Docket Number:	08-AFC-09C
Project Title:	Palmdale Energy Project (Formerly Palmdale Hybrid Power Plant) - Compliance
TN #:	220286
Document Title:	Palmdale Energy Project Amendment - Staff Comments on the Presiding Member's Proposed Decision
Description:	Staff Comments on the Presiding Member's Proposed Decision
Filer:	Raquel Rodriguez
Organization:	California Energy Commission
Submitter Role:	Energy Commission
Submission Date:	7/20/2017 3:14:37 PM
Docketed Date:	7/20/2017

Subject: **Palmdale Energy Project Amendment (08-AFC-09C); Staff Comments on the Presiding Member's Proposed Decision**

Noise and Vibration Figure 2
Palmdale Energy Project - Noise Measurement Location

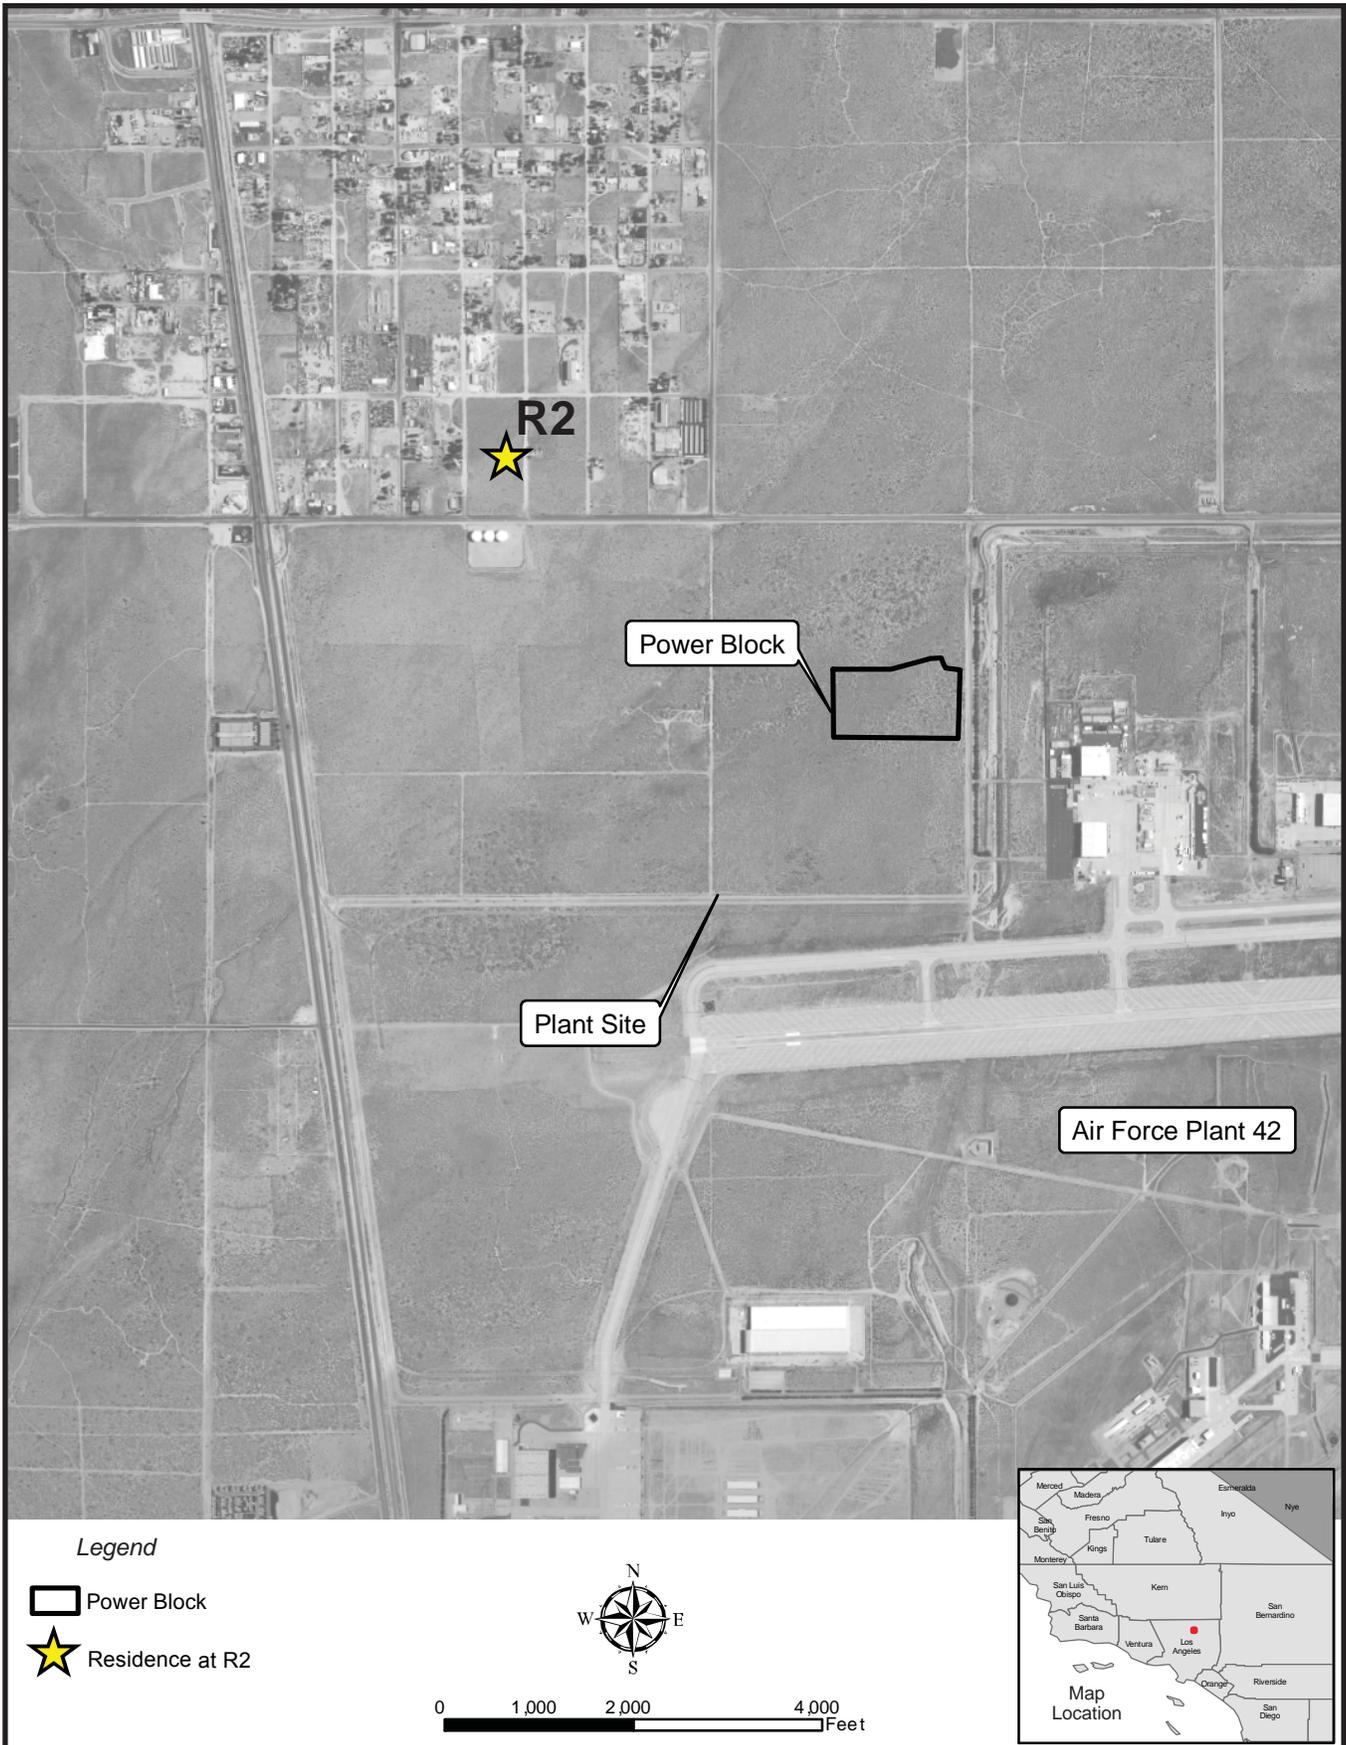
Comment 19) Figure 2, "Noise Measurement Location", is absent from the PMPD. The figure (attached by reference to this document) should be added as a new page at page 253 of Appendix A.
